**Division of Reclamation,
Mining and Safety**

Date: January 22, 2018

**Re: Loveland Ready-Mix Concrete, Inc.; Knox Pit; File No. M-2017-036;
Exhibit 6.5 – Second Geotechnical Stability Exhibit Review**

Mine Slope Analysis - 50' Offset

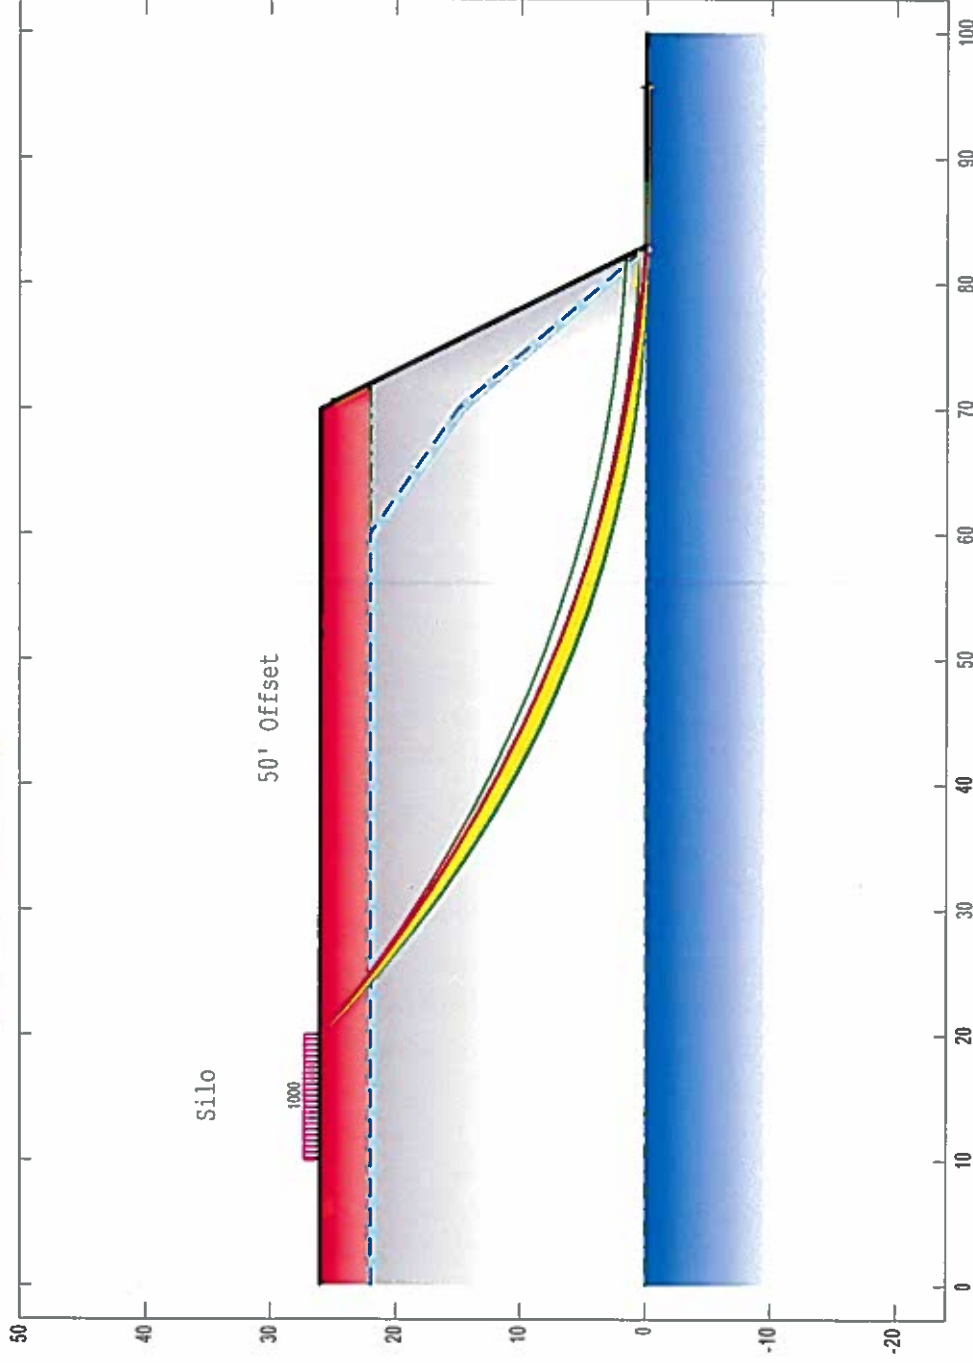
Pre-Reclamation Slope Stability

The Applicant's cross section was duplicated for verification. The factor of safety produced by Galena (1.35) was lower than the factor of safety produced by the Applicant's calculation (1.7). The factor of safety is greater than the required factor of safety of 1.3. Therefore, the accuracy of the Applicant's calculation is confirmed. A copy of the Galena model is attached.

Generic Worst-Case Post Reclamation Scenario

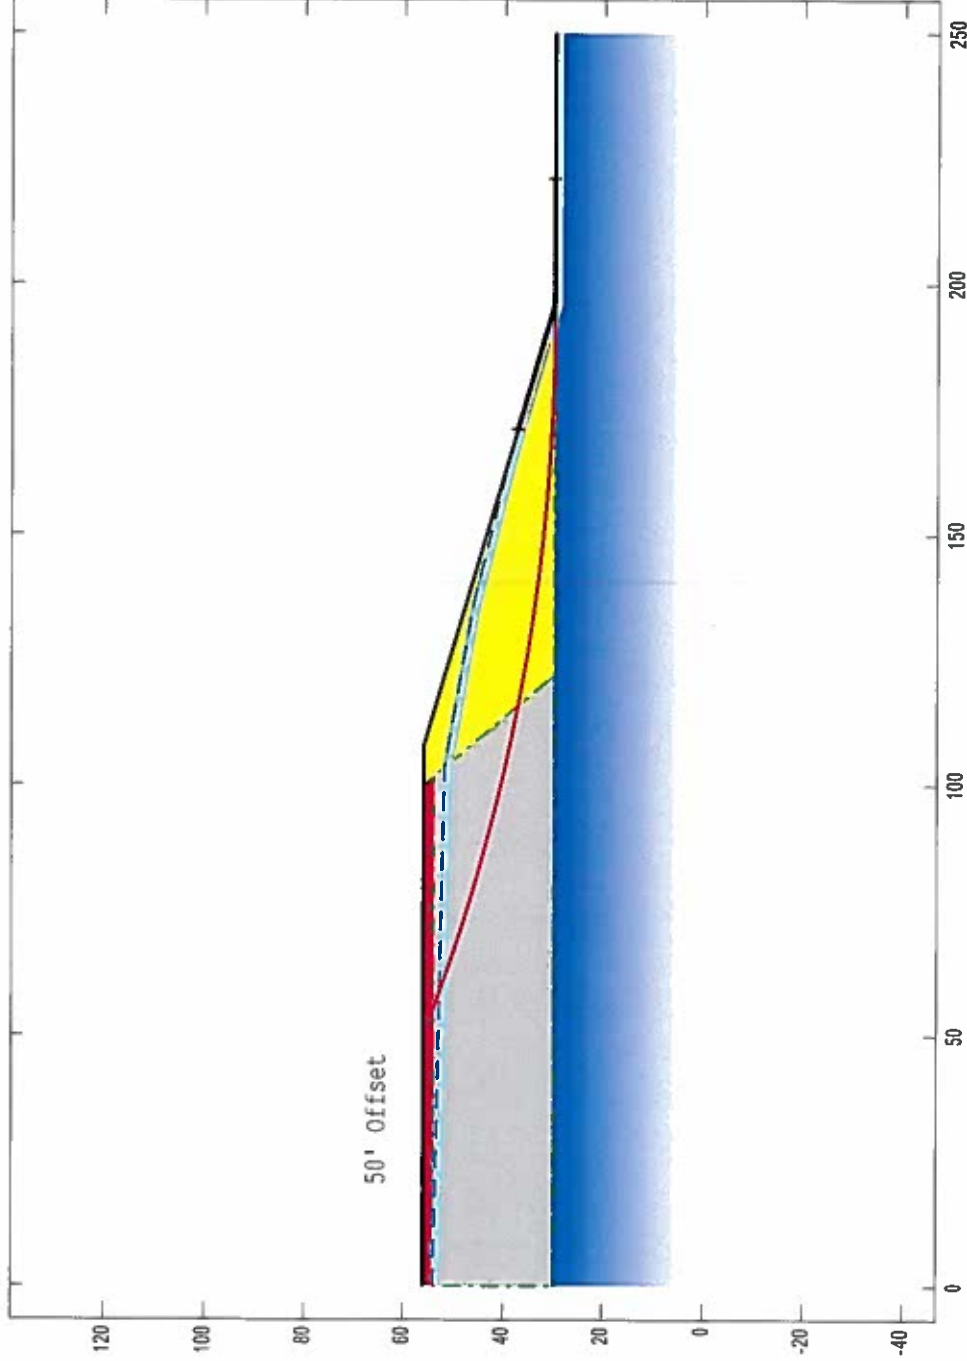
Generic Worst-Case Post Reclamation Scenario

The Applicant's cross section was duplicated for verification. The factor of safety produced by Galena (1.88) was greater than the required factor of safety of 1.3. Therefore, the stability of the cross section is acceptable. A copy of the Galena model is attached.

File: C:\Users\p...l\Post Reclamation Platte River Power Authority Cross-Section 50' Offset.gmf

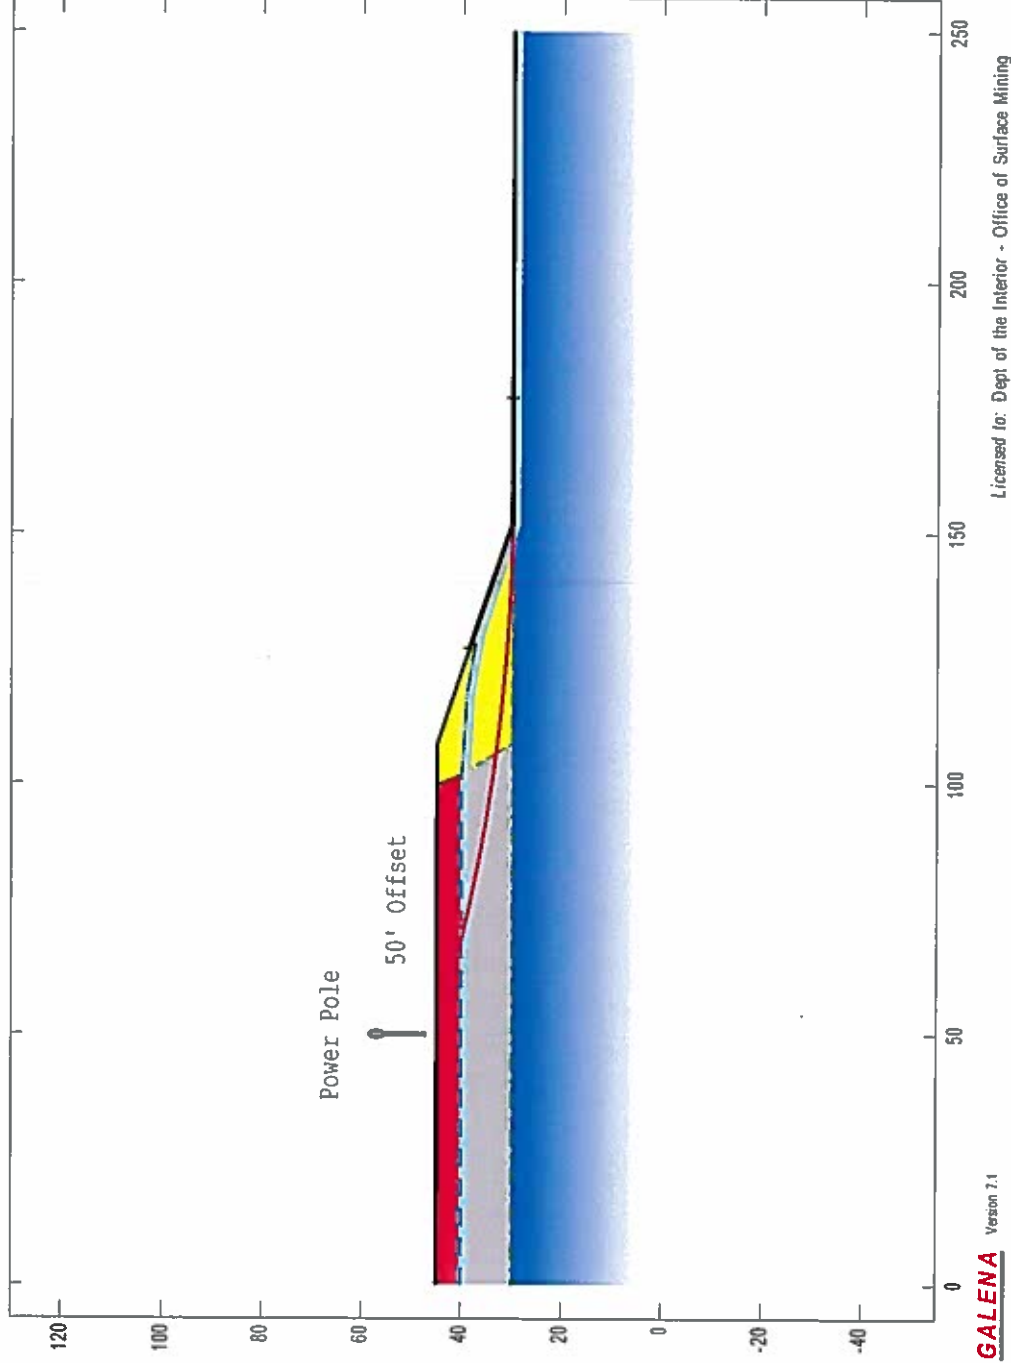
Post Reclamation Platte River Power Authority Cross-Section – 50' Offset

The Applicant's cross section was duplicated for verification. The factor of safety produced by Galena (3.28) was lower than the factor of safety produced by the Applicant's calculation (3.71). The factor of safety is greater than the required factor of safety of 1.3. Therefore, the accuracy of the Applicant's analysis is confirmed. A copy of the Galena model is attached.

File: C:\Users\p...Post Reclamation Platte River Power Authority Cross-Section 30' Offset.gmf

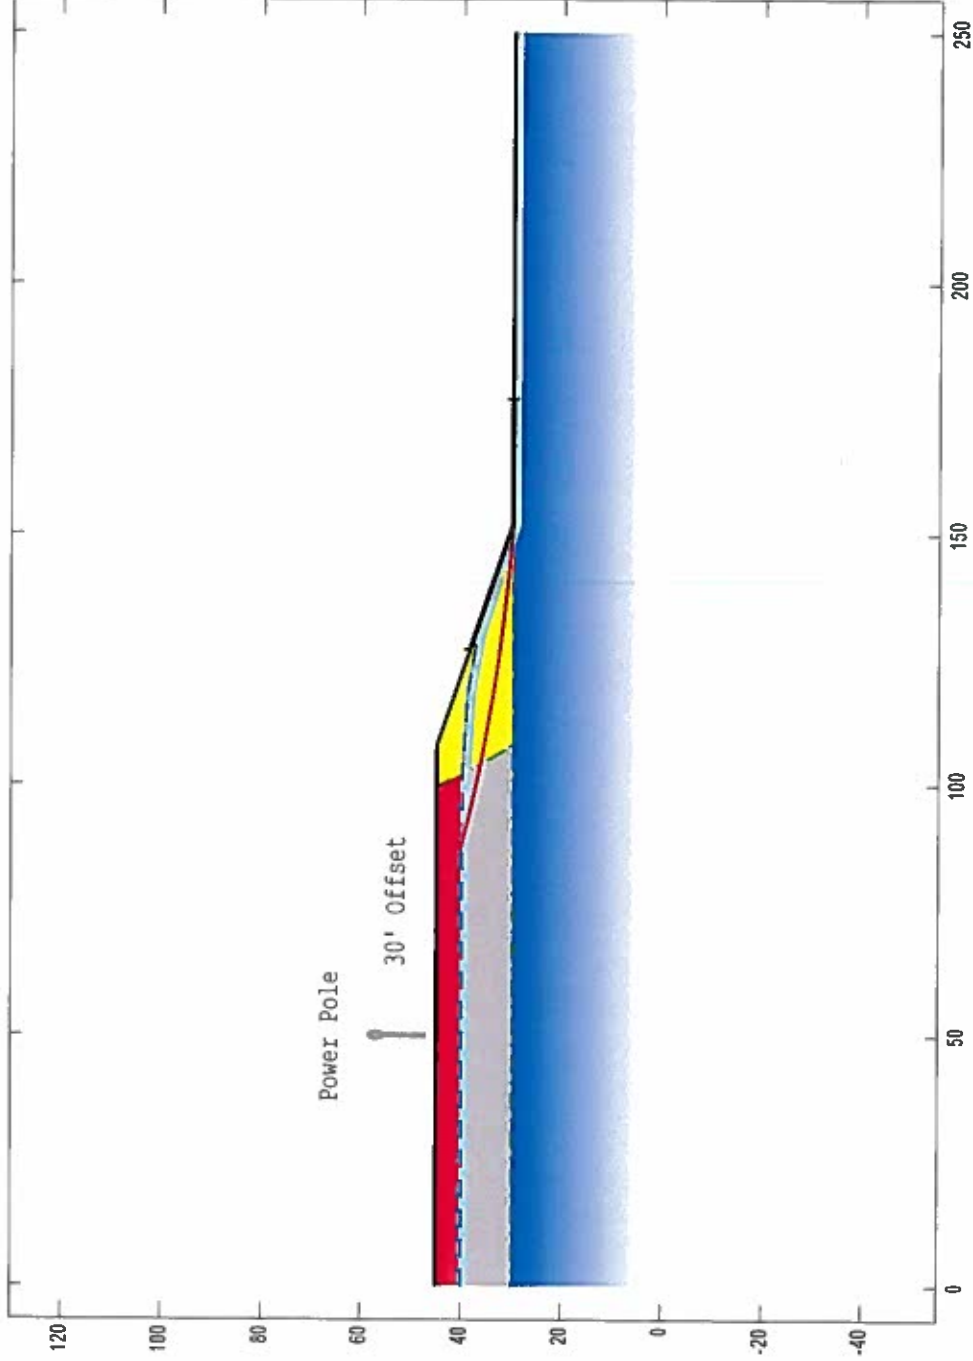
Post Reclamation Platte River Power Authority Cross-Section – 30' Offset

The Applicant's cross section was duplicated for verification. The factor of safety produced by Galena (2.51) was greater than the factor of safety produced by the Applicant's calculation (2.01). The factor of safety is greater than the required factor of safety of 1.3. Therefore, the accuracy of the Applicant's analysis is confirmed. A copy of the Galena model is attached.

File: C:\Users\p...Post Reclamation Cache La Poudre Ditch Cross-Section 50' Offset.gml

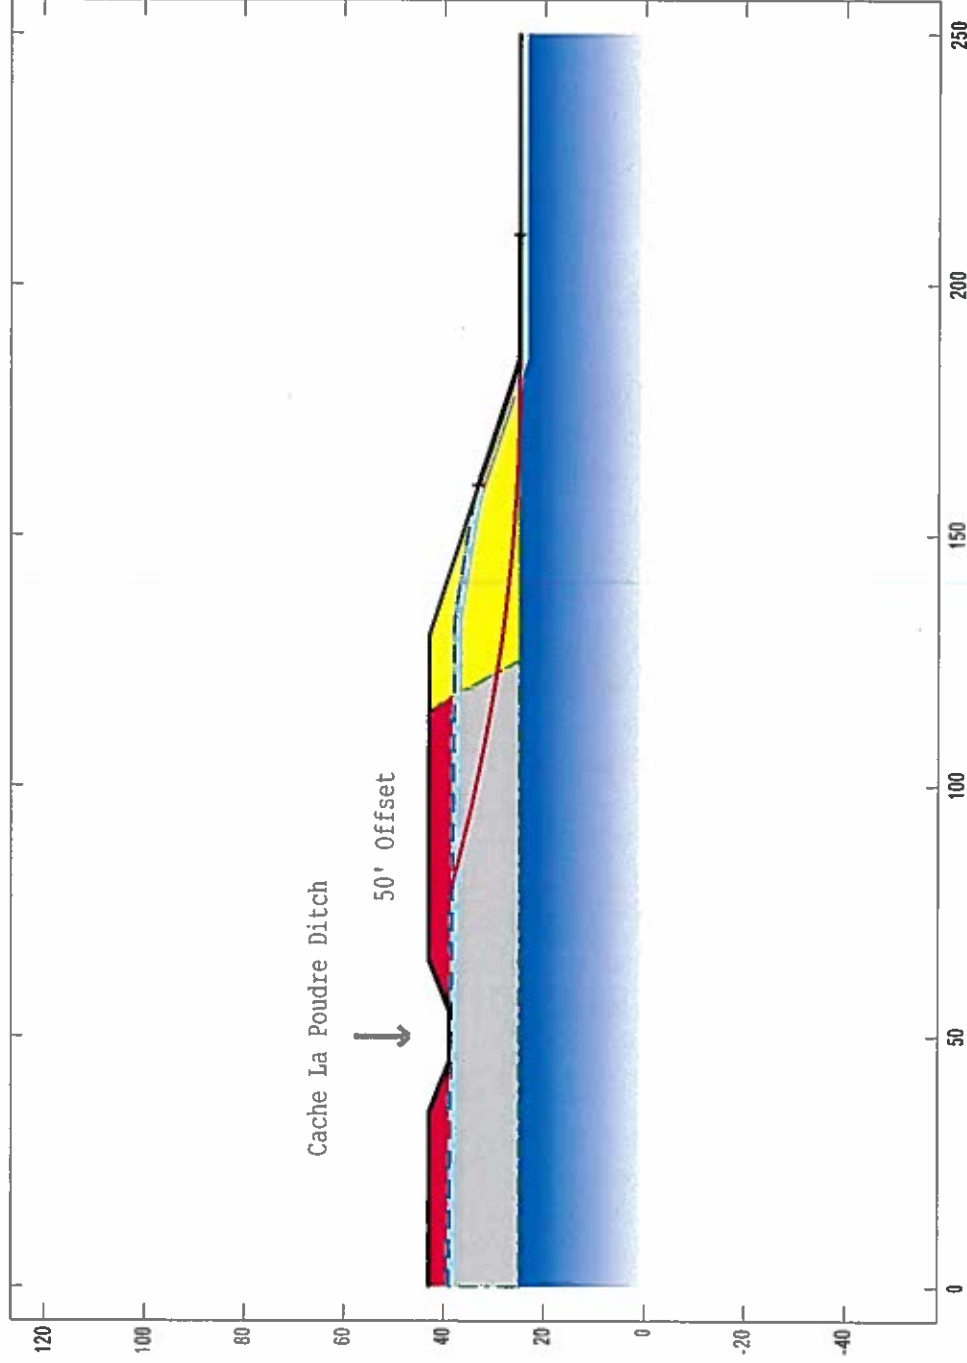
Post Reclamation Cache La Poudre Ditch Cross-Section – 50' Offset

The Applicant's cross section was duplicated for verification. The factor of safety produced by Galena (2.84) was lower than the factor of safety produced by the Applicant's calculation (3.74). The factor of safety is greater than the required factor of safety of 1.3. Therefore, the accuracy of the Applicant's analysis is confirmed. A copy of the Galena model is attached.

File: C:\Users\p...Post Reclamation Cache La Poudre Ditch Cross-Section 30' Offset.gmf

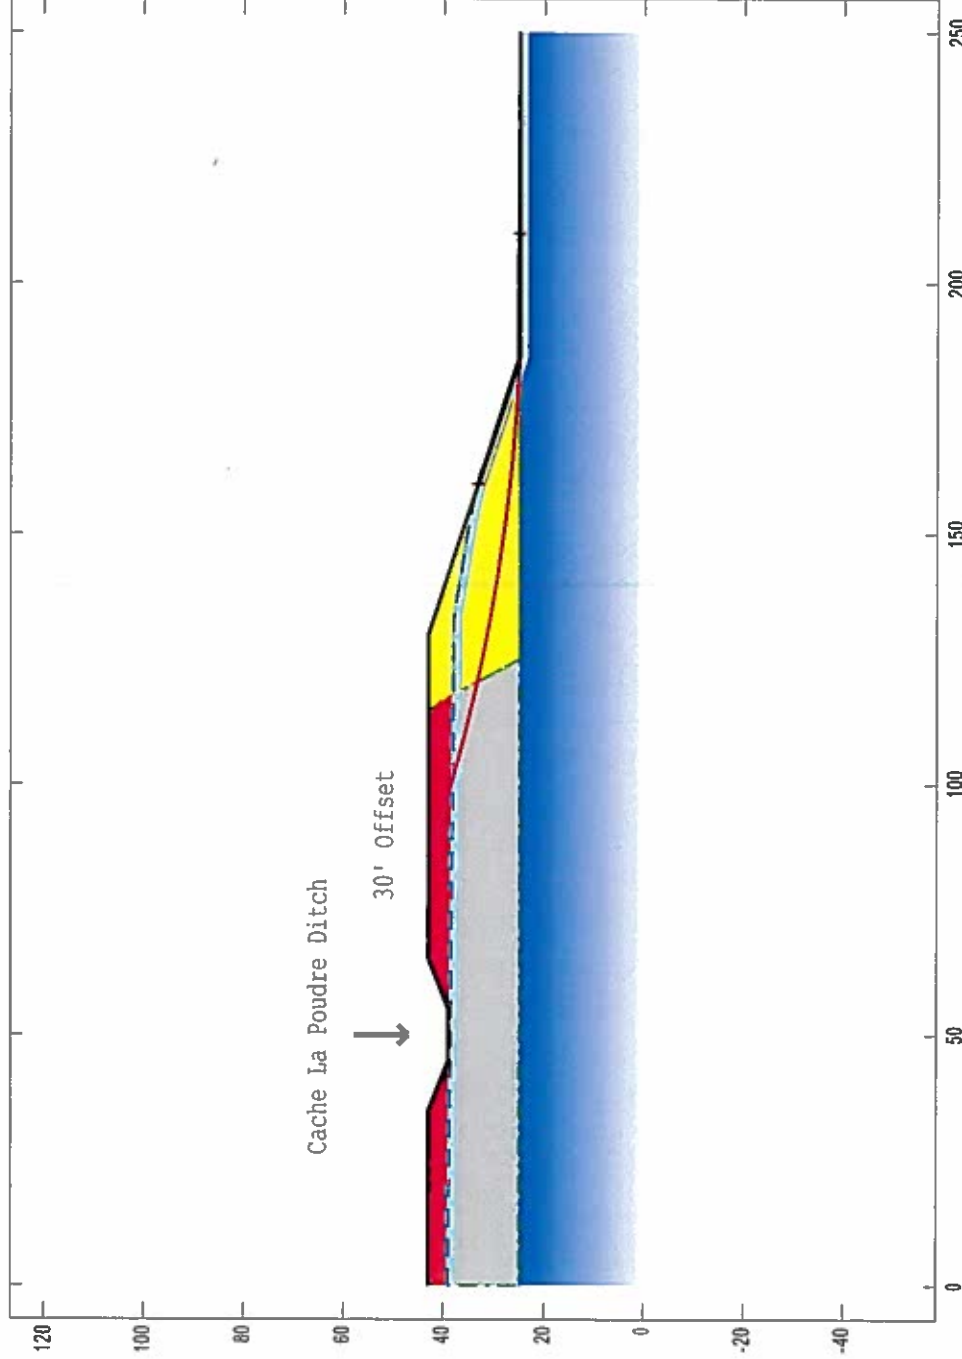
Post Reclamation Cache La Poudre Ditch Cross-Section – 30' Offset

The Applicant's cross section was duplicated for verification. The factor of safety produced by Galena (2.23) was greater than the factor of safety produced by the Applicant's calculation (1.89). The factor of safety is greater than the required factor of safety of 1.3. Therefore, the accuracy of the Applicant's analysis is confirmed. A copy of the Galena model is attached.
